MAJOR REPAIR AND ALTERATION (Airframe, Powerplant, Propeller, or Appliance)

and disposit	iONS: Print or type all i tion of this form. This r thiviolation (Section 9	eport is required b	y law (•	49 U.	.S.C. 1421) P	allure to rep	port can result in a	civil pena	ity not folexce	ed \$1,000	
	Make	<u>-</u> _				Model					
	PIPER					PA-	22/20-150

Lt. Window Atteration

N3328Z Ser. # 22-7265

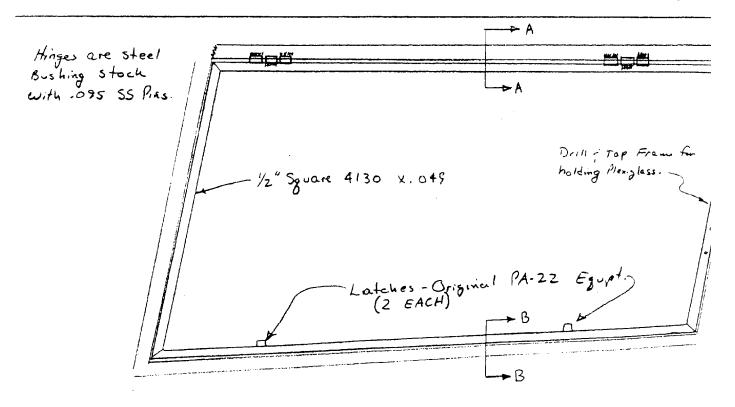
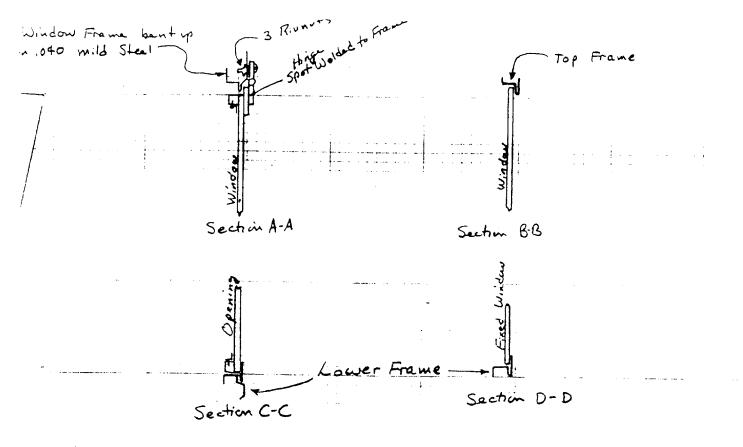
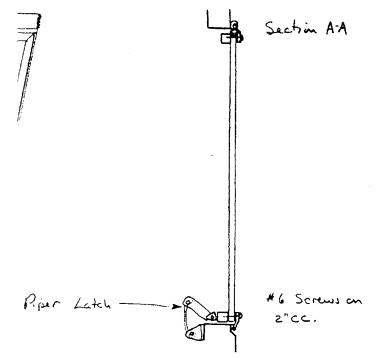
This Form 337 request is to make the left window so that it can be opened to the same extent as the small one was, as was originally designed and built. This alteration will eliminate the vertical frame that has always interfered with the pilots view to the left. The latch system will be the same as original except that two will be used. The opening restriction will not be changed.

Uppor of Lower window from material is .040 Mild Steel formed in a brake to shape indicated.
